EXHIBIT A: Marked-Up Version Of The Amended Paragraph Of The Specification

J.A. ABYS 52-14-6-6

FIG. 2

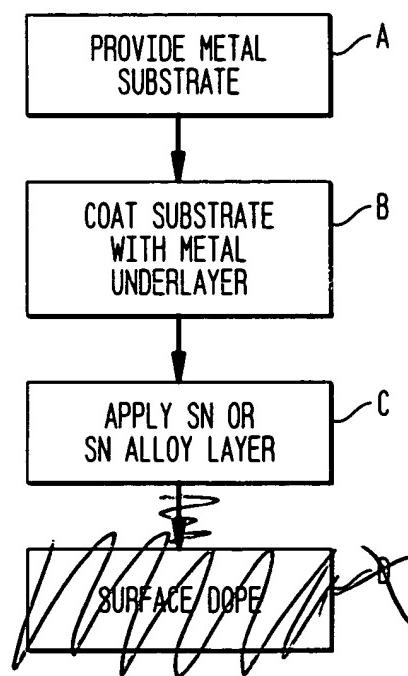
recite "B" in the proper context. In addition, Applicant has amended FIG. 2 to remove "D" and its associated Box reciting "SURFACE DOPE". A corrected version of FIG. 2 is filed herewith.

FIG. 7A

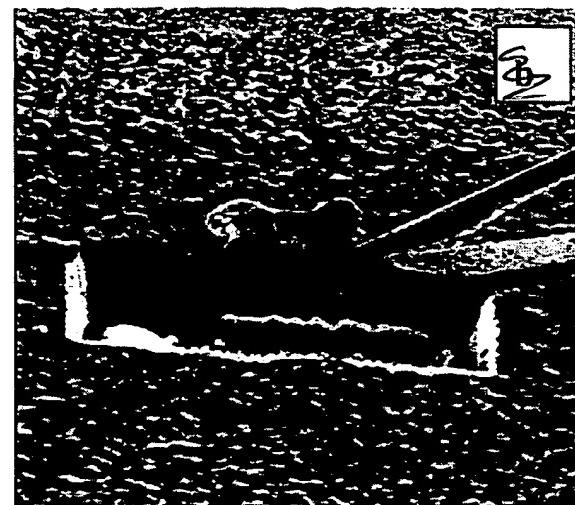
FIG. 7 stands objected to on the grounds that reference signs "a", "b", and "c" depicted in FIGS. 7A-7B respectively are not recited in the Specification. In response, Applicant has amended FIGS. 7A-7B to remove reference signs "a", "b", and "c". Corrected versions of FIGS. 7A-7B are filed herewith.
